UNITED STATES PATENT AND TRADEMARK OFFICE

APPLICATION NO.	FILING DATE	FIRST NAMED INVENTOR	ATTORNEY DOCKET NO.	CONFIRMATION NO.
10/582,405	04/24/2007	Tadahisa Tanaka	2006_0885A	4716
513 7590 06/10/2009 WENDEROTH, LIND & PONACK, L.L.P. 1030 15th Street, N.W., Suite 400 East Washington, DC 20005-1503				
EXAMINER				
LIU, HENRY Y				
ART UNIT		PAPER NUMBER		
3657				
MAIL DATE		DELIVERY MODE		
06/10/2009		PAPER

DETAILED ACTION

This is the first action on the merits for application 10/582405. **Claims 1 and 2** are pending, of which **Claims 1 and 2** are in independent form.

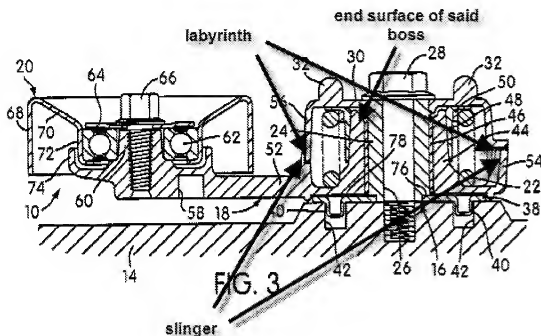
BELLAMY teaches a boss (44) being formed with a shaft inserting hole, a tubular fulcrum shaft (24) mounted in said shaft inserting hole, a bolt (28) axially extending through said fulcrum shaft (24) and configured to be brought into threaded engagement with an engine block (Col. 2 lines 40-55) and tightened to fix said fulcrum shaft (24) to the engine pulley (20), thereby pivotally supporting said pulley arm (18) (Fig. 3).

BELLAMY teaches a washer (30) (Fig. 3) disposed between a head of said bolt (28) and an end surface of said boss (44), said washer having a cylindrical portion (56) (Fig. 3) covering an end portion of said boss (44) including said end surface, and that a slinger is mounted on said end portion of said boss (44), said cylindrical portion (56) of said washer (30) and said slinger defining a labyrinth therebetween." See figure below.

It would have been obvious to one of ordinary skill in the art at the time the invention was made to modify the tension adjusting device in KATOGLI with the pivot mounting structure and labyrinth for preventing entry of contaminants in BELLAMY. The combination results in a cost effective pivot mount which provides protection from contaminants.

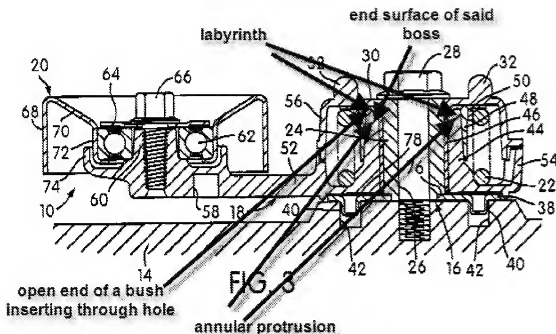
BELLAMY teaches a washer (30) disposed between opposed surfaces of said bush (24) and a mounting surface (12) (Fig. 1) and between opposed surfaces of said bush (24) and a head of said bolt (28) (Fig. 3). The washer has a cylindrical portion (56) extending toward a coupling piece (18), which has an annular protrusion at an open end of a bush inserting through hole, said cylindrical portion (56) of the washer and annular protrusions defining a labyrinth therebetween." See figure below.

It would have been obvious to one of ordinary skill in the art at the time the invention was made to modify the tension adjusting device in KATOGLI as modified with the mounting structure and labyrinth for preventing entry of contaminants in BELLAMY. The combination results in a cost effective hydraulic tensioner mount which provides protection from contaminants.

BELLAMY does not teach the use of two washers and two annular protrusions.

It would have been obvious to one of ordinary skill in the art at the time the invention was made to modify the tensioning device in KATOGLI as modified to utilize two of the labyrinth structures in BELLAMY arranged with one on each side of the coupling piece, since it has been held that mere duplication of the essential working parts of a device involves only routine skill in the art. *St. Regis Paper Co. v. Bemis Co.*,
